Certificate of Substantial Completion

(Name and address)
Oak Creek Village Apartments
2324 Wilson Street
Austin, Texas 78704

Field Report: Oak Creek Village Apartments, Phase 1

Bercy Chen Studio

General, 06
Balconies

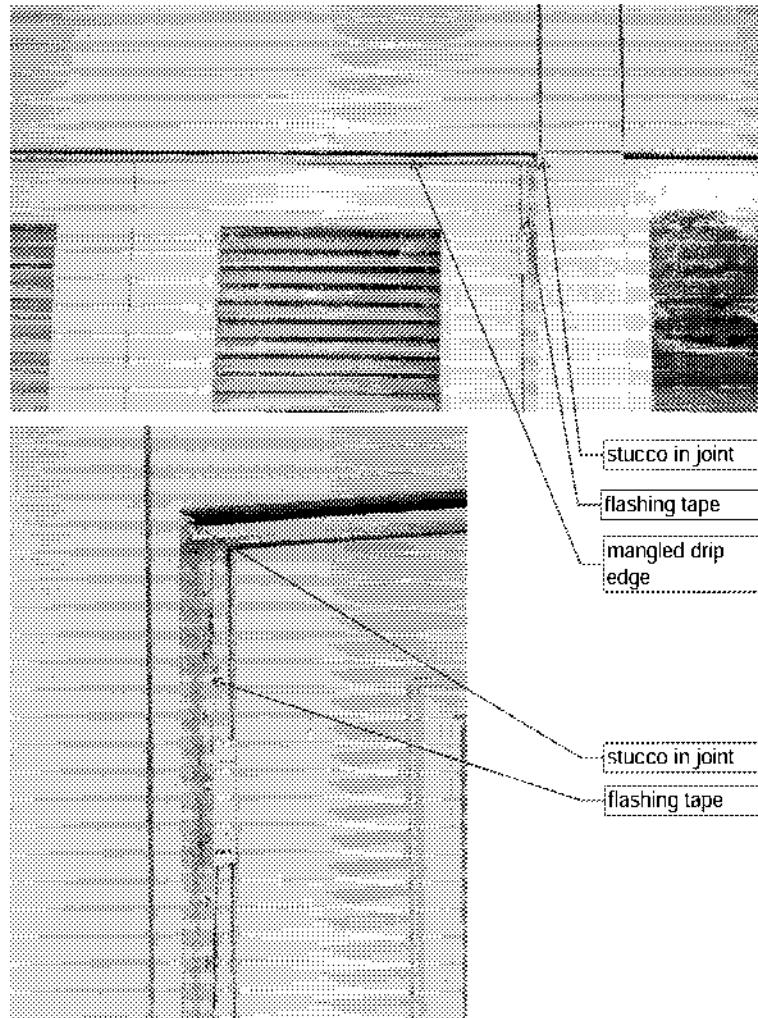
Seal edges of soffit vent covers & outlets to soffit board, paint.

General, 09
EIFS

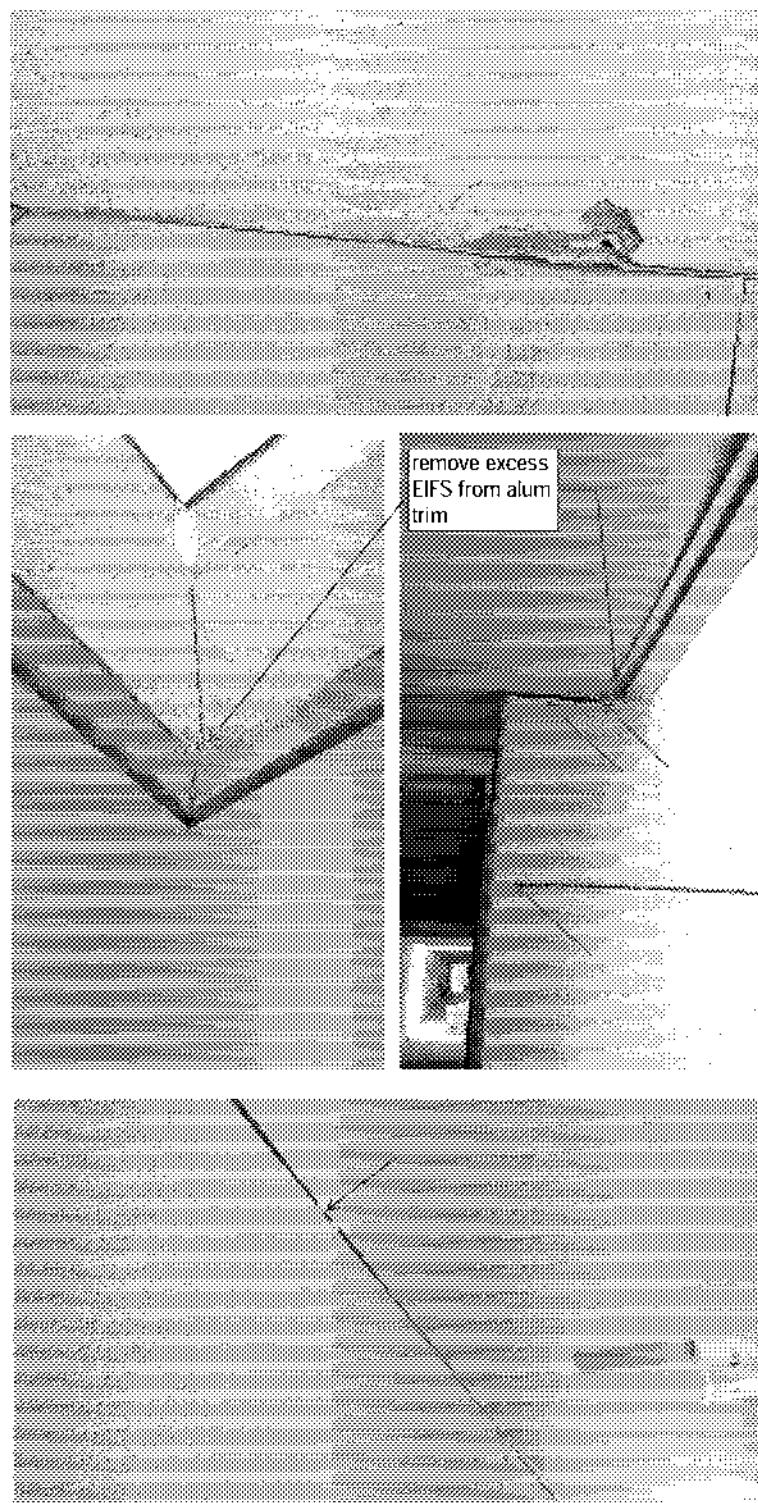
Typical EIFS issues:

- Material in ends of reveal joints
- Texture inconsistency & flaws - divots, drops, scratches, etc
- Bottom edge flashing clogged with EIFS debris
- Run-off staining
- Concrete work splatter
- Damaged edges
- Reveal joints not installed straight/level/plumb

Building 3 21
connection to
Building 4,
Level 3

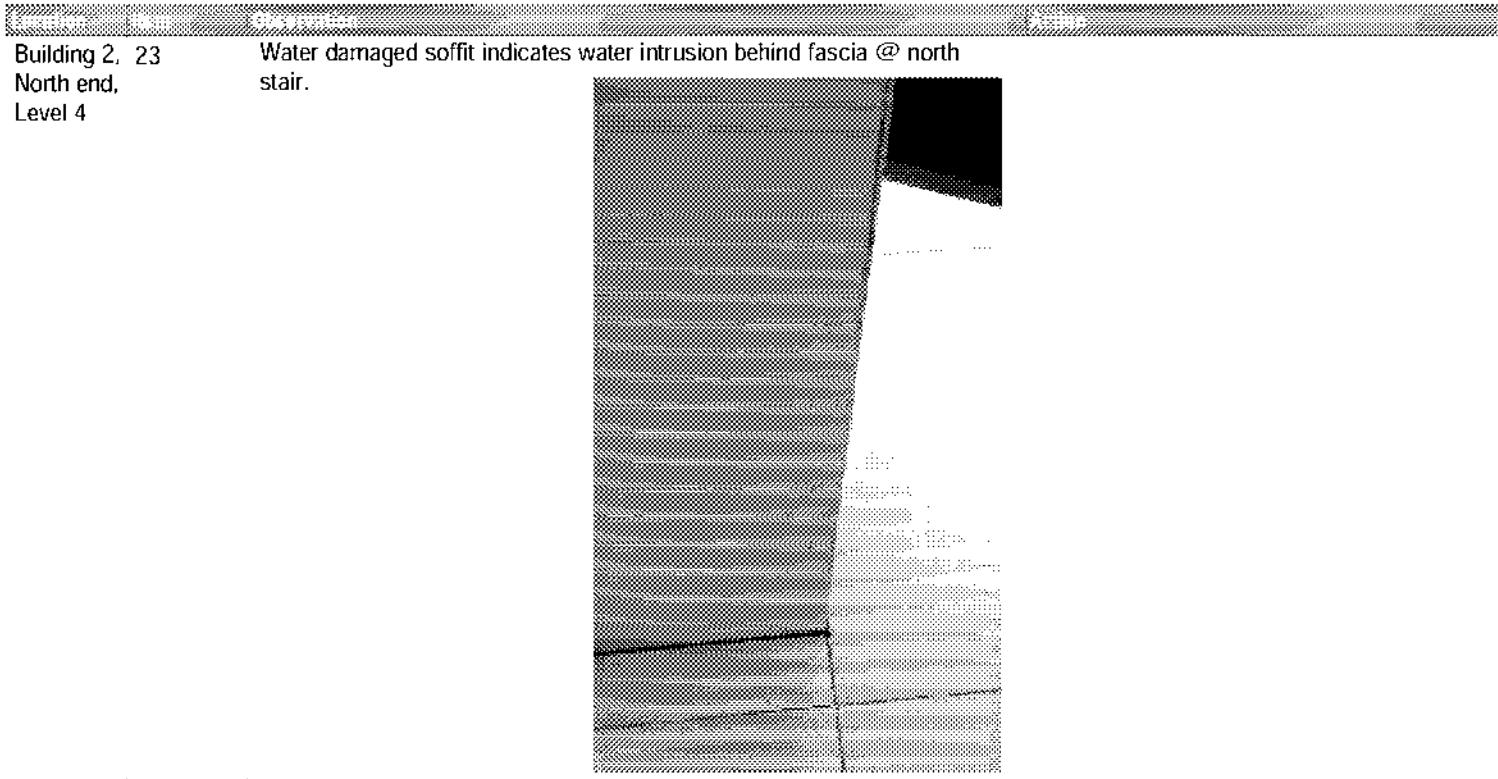
The clear width of this opening, from catwalk to upper courtyard, MUST be 36" for AFD access requirements. Please confirm.

Building 2, 23
North end,
Level 4

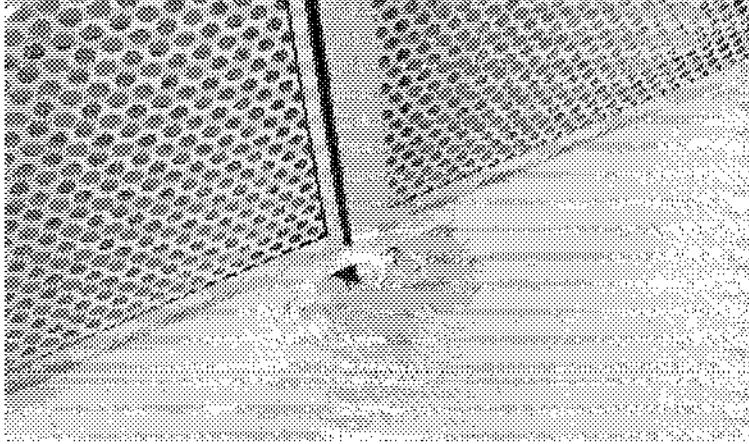
Water damaged soffit indicates water intrusion behind fascia @ north stair.

Garage #9
Air Shafts

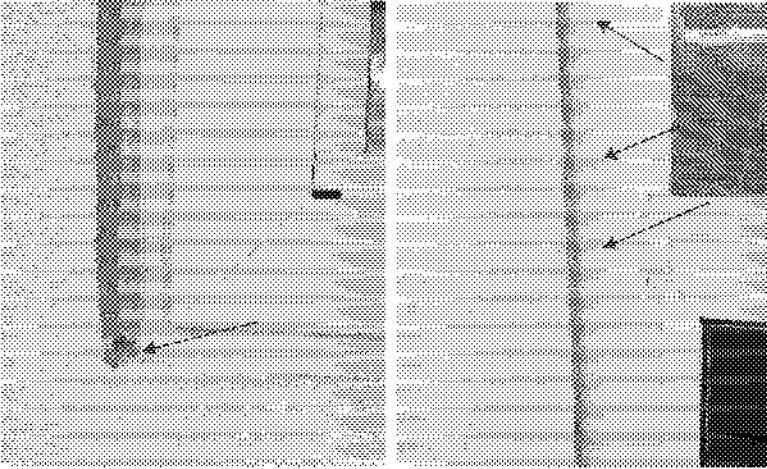
Both air shafts were observed to be covered at time of inspection, due to nearby surface-level site work. Maintain code-required monitoring and air change at all times when garage is occupied and used by tenants.

Corridors #19
, Lighting

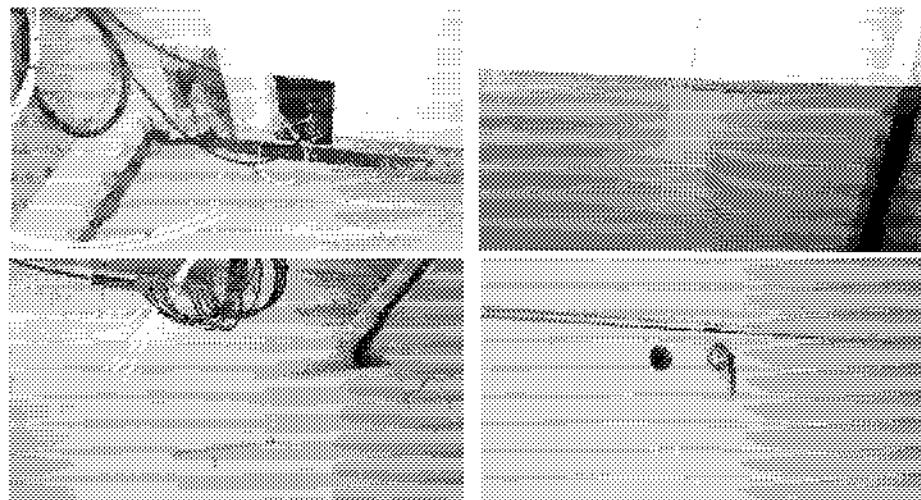
Soffit above light fixtures is unpainted. Surprisingly large amounts of dead bugs were observed in the lenses of many lights - recommend checking that wiring knock-outs are sealed around cabling, and lenses are properly secured.

Buildings #16
1&3, Level
5&6

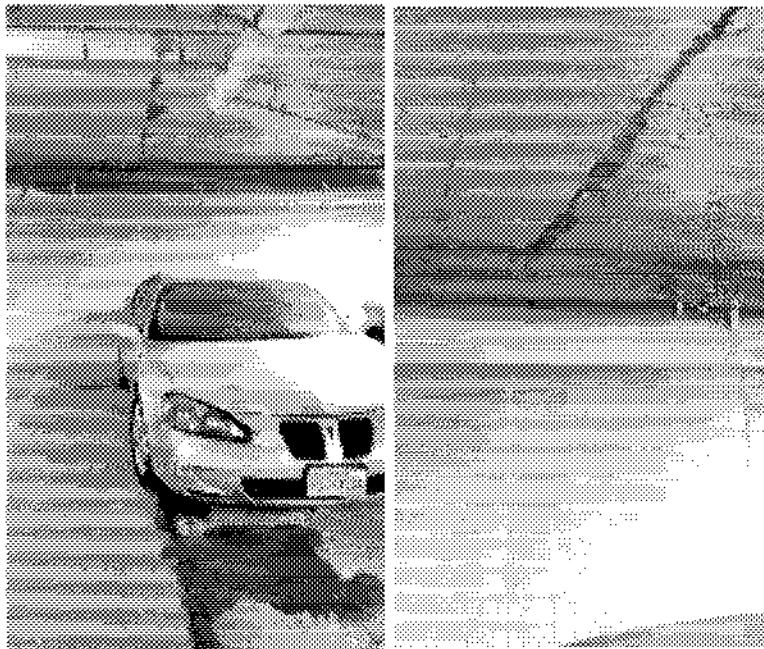
TPO seaming material has been used to seal sheet metal cap flashing at numerous locations. TPO material drops over the edge of the sheet metal cap flashing at other, seemingly random locations, visible from the walkway below. Multiple short pieces of sheet metal have been used to flash continuous edges at numerous locations, creating unnecessary joints. Gap visible under parapet cap flashing - flashing height not adequate to lap onto stucco below

Garage, #17
G2, East
wall

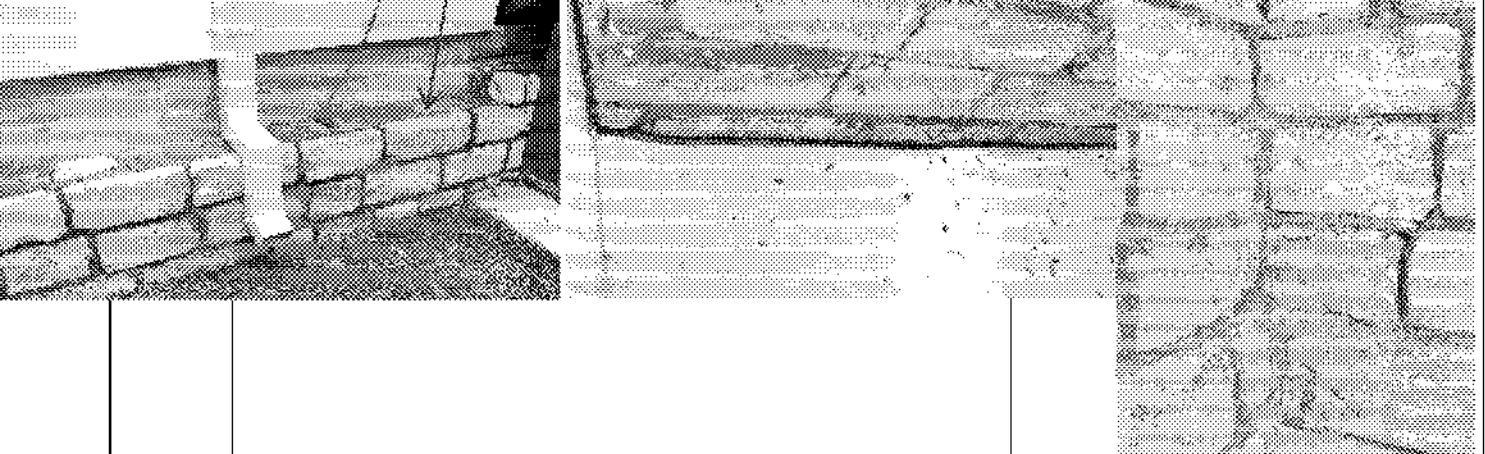
Water is leaking down into the parking garage from the ceiling of the garage, over parking space #8.
